Business Unit: Electronics **PCN/18/019/PM+MD - US**

Product range: M12 Circular Connectors **Date:** 2018-10-03

Title: Modification of har-speed M12 Angled PCB Receptacles **Page** 1/2

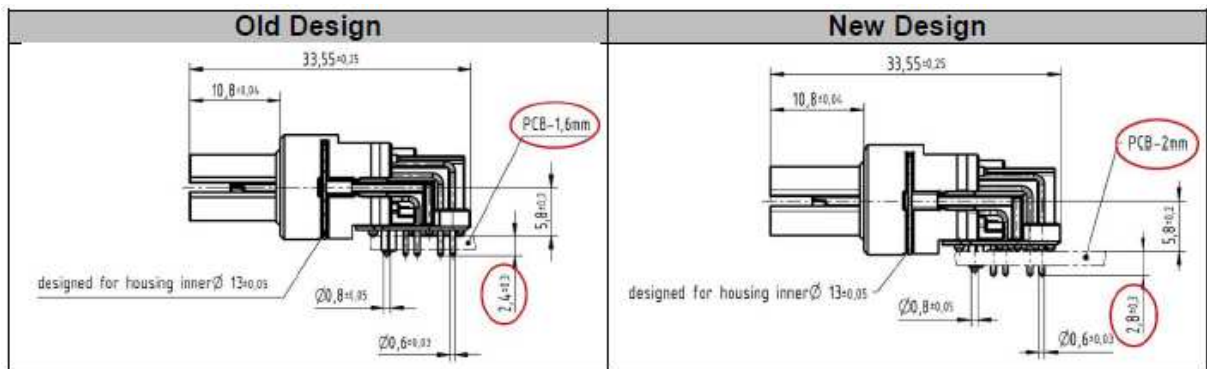
Length modification of the PCB side pins. Length of the pins has been extended by additional 0.4 mm (total length of 2 mm), making this product line suitable for 2 mm thick printed circuit boards.

This change does not have any impact on fit, form or function of this product line. The outer dimensions and footprint of the products remain unchanged.
